CNL-20-009

June 12, 2020

Subject: **Sequoyah Nuclear Plant Unit 1 and Unit 2 – License Amendment Request to Revise Technical Specification 4.2.2, “Control Rod Assemblies” (SQN-TS-20-04)**

EVALUATION OF THE PROPOSED CHANGE

Figure 1 - Control Rod Locations

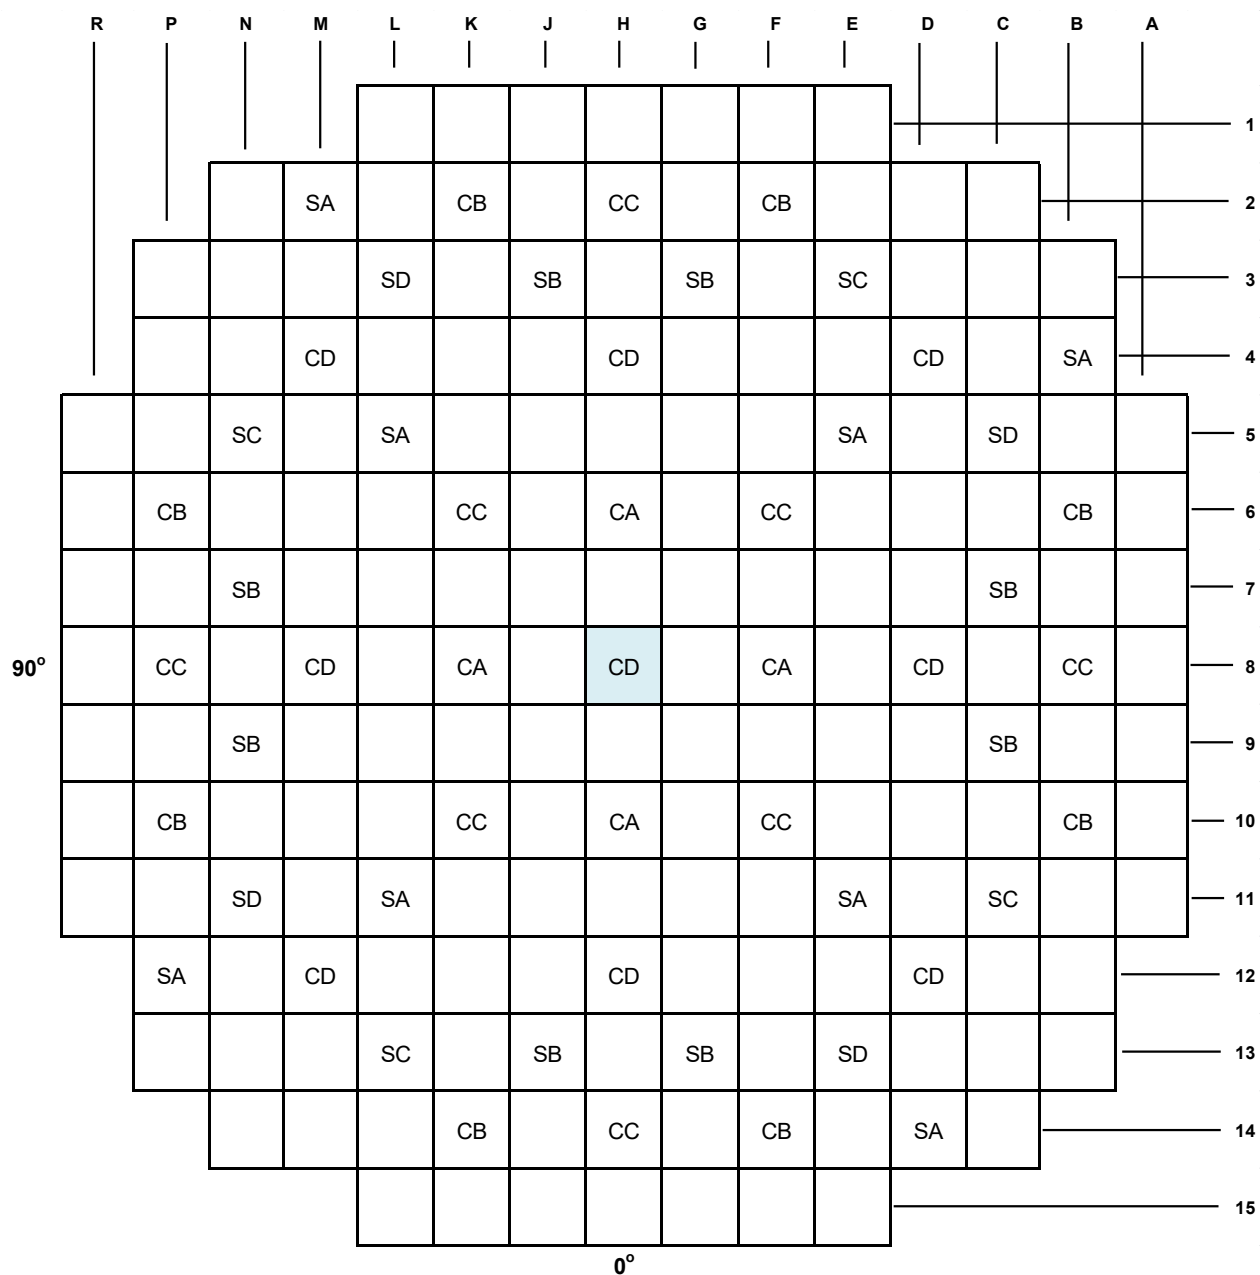
The H-08 control rod is part of Control Bank D and is located in the center of the core as shown in Figure 1. With the removal of the H-08 control rod, U1C24 and U2C24 cores contain 52 full length control rod assemblies as shown in the table to Figure 1. The H-08 control rod would remain removed for U1C25 and U2C25.

Note: The control rods in core location H-08 were removed for U1C24 and U2C24 and will remain removed for U1C25 and U2C25.

Operation with 52 full length control rod assemblies (with no control rod assembly installed in core location H-08) is permitted during Cycles 24 and 25.
